Access Compliance Report

(Curb Ramps)

Intersection ID: 49656	Main Street: SKYLINE_VIEW_WY	Cross Street: SEIGLE_POINT_DR	Location: E
ADA ID: 54A582673424	Ramp Type: Perp	Initial Pass/Fail: Fail	Overall Compliance: No
Severity Score: 12.5			
Codes/Mitigation Info/Possible Solution		Field Measurements/Component Compliance

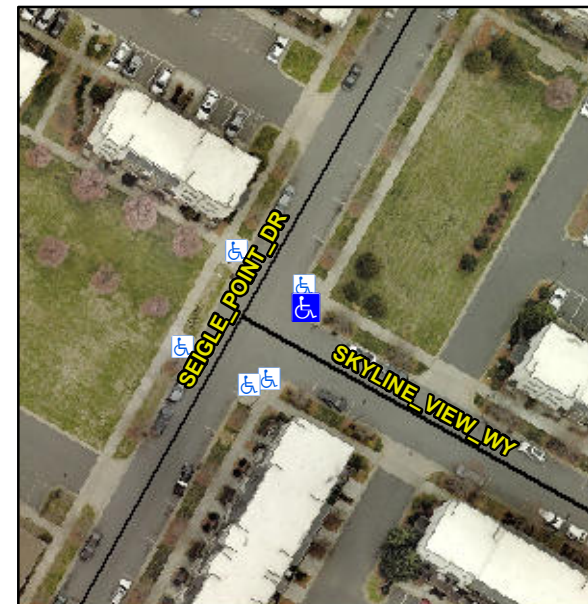
Compliance	Description	Data	Compliance	Description	Data
N/A	Ramp Length (in)	66.0	No	Ramp Slope (%)	8.4
Yes	Ramp Width (in)	76.5	Yes	Ramp XSlope (%)	0.8
N/A	Flare Type LT	N/A	N/A	Flare Type RT	N/A
N/A	Flare Slope LT (%)	N/A	N/A	Flare Slope RT (%)	N/A
N/A	Flare Traversable LT?	N/A	N/A	Flare Traversable RT?	N/A
N/A	Landing Length (in)	N/A	N/A	DWS Provided?	N/A
N/A	Landing Width (in)	N/A	N/A	DWS Contrast?	N/A
N/A	Landing Slope (%)	N/A	N/A	DWS Length (in)	N/A
N/A	Landing X Slope (%)	N/A	N/A	DWS Full Width?	N/A
N/A	Landing Curb? (Y/N)	N/A	N/A	DWS Offset (in)	N/A
N/A	Shared Landing?	N/A			
N/A	Gutter Ponding?	N/A	N/A	Gutter Slope (%)	N/A
N/A	Gutter Lip Ht (in)	N/A	N/A	Gutter X Slope (%)	N/A
N/A	Painted X Walk1?	No	N/A	Painted X Walk2?	N/A
	X Walk 1 Direction	To SW		X Walk 2 Direction	N/A
N/A	X Walk 1 Width (in)	N/A	N/A	X Walk 2 Width (in)	N/A
	X Walk 1 Slope (%)	1.7		X Walk 2 Slope (%)	N/A
	X Walk 1 X Slope (%)	1.5		X Walk 2 X Slope (%)	N/A

Remove & Replace Entire Ramp.
